Access Compliance Report Public Rights-of-Way (Curb Ramps)

Intersection ID: N/AMain Street:WOODLAWN_STCross Street: N/ANEADA ID: D0FCD55BACE3Ramp Type:PerpInitial Pass/Fail:FailOverall Compliance: NoSeverity Score:1.25

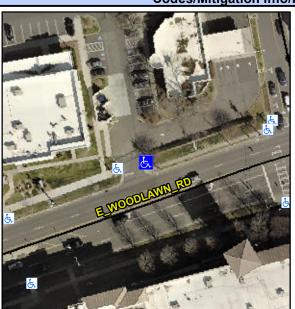
Possible Solutions:						
Remove & Replace Entire Ramp.						
•						
Surveyor Notes:						
N/A						
PROW/ADA:						
R304.5.3						
1004.0.0

Comp	liance Description	Data	Comp	liance Description	Data
N/A	Ramp Length (in)	24.0	Yes	Ramp Slope (%)	6.5
Yes	Ramp Width (in)	48.0	No	Ramp XSlope (%)	2.9
N/A	Flare Type LT	N/A	N/A	Flare Type RT	N/A
N/A	Flare Slope LT (%)	N/A	N/A	Flare Slope RT (%)	N/A
N/A	Flare Traversable LT?	N/A	N/A	Flare Traversable RT?	N/A
N/A	Landing Length (in)	N/A	N/A	DWS Provided?	N/A
N/A	Landing Width (in)	N/A	N/A	DWS Contrast?	N/A
N/A	Landing Slope (%)	N/A	N/A	DWS Length (in)	N/A
N/A	Landing X Slope (%)	N/A	N/A	DWS Full Width?	N/A
N/A	Landing Curb? (Y/N)	N/A	N/A	DWS Offset (in)	N/A
N/A	Shared Landing?	N/A			
N/A	Gutter Ponding?	N/A	N/A	Gutter Slope (%)	N/A
N/A	Gutter Lip Ht (in)	N/A	N/A	Gutter X Slope (%)	N/A
N/A	Painted X Walk1?	No	N/A	Painted X Walk2?	N/A
	X Walk 1 Direction	To W		X Walk 2 Direction	N/A
N/A	X Walk 1 Width (in)	N/A	N/A	X Walk 2 Width (in)	N/A
	X Walk 1 Slope (%)	3.5		X Walk 2 Slope (%)	N/A
	X Walk 1 X Slope (%)	0.3		X Walk 2 X Slope (%)	N/A
